UNITED STATES
NUCLEAR REGULATORY COMMISSION
WASHINGTON, D. C. 20555

SUBJECT: REVIEW OF CONSULTANT REPORTS FOR TMI-1

ABSTRACT

Figure 3-1 GPU Nuclear Corporation

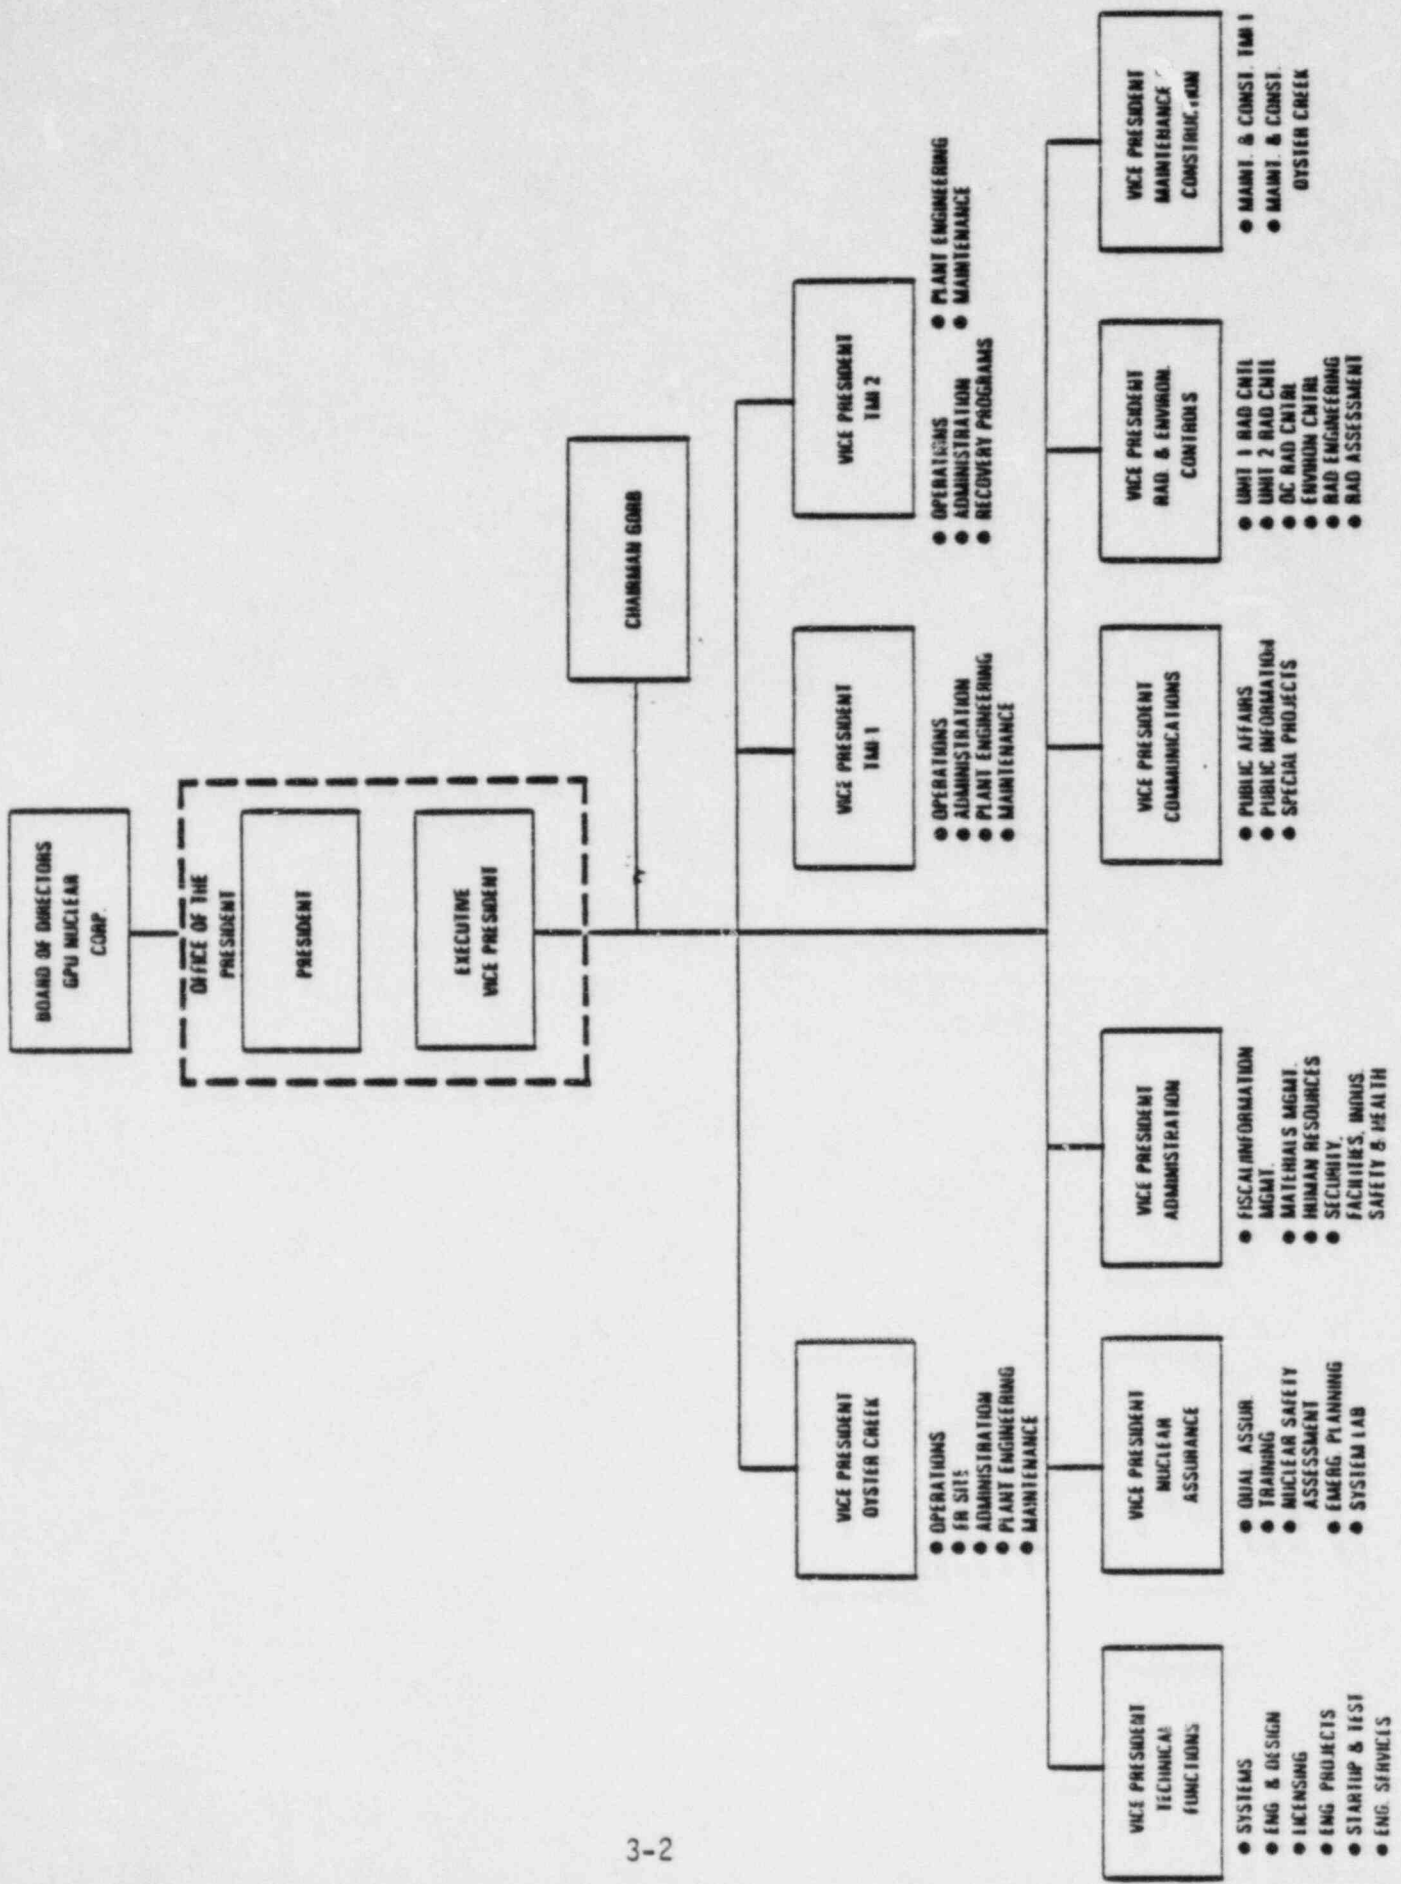
About 20% of the RHR survey effort was devoted to exploring operator attitudes and perceptions regarding organizational issues (see Appendix B, questions 68-96). Overall, among all individuals surveyed, RHR determined that cooperation between departments was the third highest priority issue, although this issue appeared to be more of a concern among Oyster Creek operators than at TMI-1, and it was limited principally to a concern of the senior reactor operators at the two plants.

Based upon the survey results, the TMI-1 operators agreed that the concept of a functional organization made sense (73)* and that the new organization was

designed to promote safer operation (69). However, they were concerned about how well the new organization was working in practice (74) and they felt strongly that the various departments needed to find better ways to work together (77). They felt that the other departments needed more knowledge of plant operations so as to better understand the effects of their actions on operations (93) and they considered that problems would be lessened if there were better coordination among the supervisors (94). In the perception of the operators, the support departments did not have the same sense of urgency as the operations department (95), and personnel in the other departments did not have the good of the whole organization in mind when they went about their daily work (85). To the extent there is a lack of cooperation between departments, the operators blamed themselves as much as they did others (82), and attributed their attitude in part to their lack of knowledge of the roles of the other departments (79 and 90). They felt that they got good cooperation from the other departments when they knew the individuals with whom they were dealing (75), and they expressed a desire to know their counterparts in the other departments better (78). They felt that better management would alleviate problems of cooperation (94). They did not perceive any difficulty with having the necessary authority onsite to handle both routine (72) and emergency (71) actions.

GPUN has responded to this specific issue by conducting interdepartmental meetings of different levels of management, and departmental meetings at which the functions of the organization and the need for cooperation between units are discussed. Section 3.1.2.4 below describes the various planning and coordination meetings that are held at the working level to assure proper coordination among the various departments and working groups.
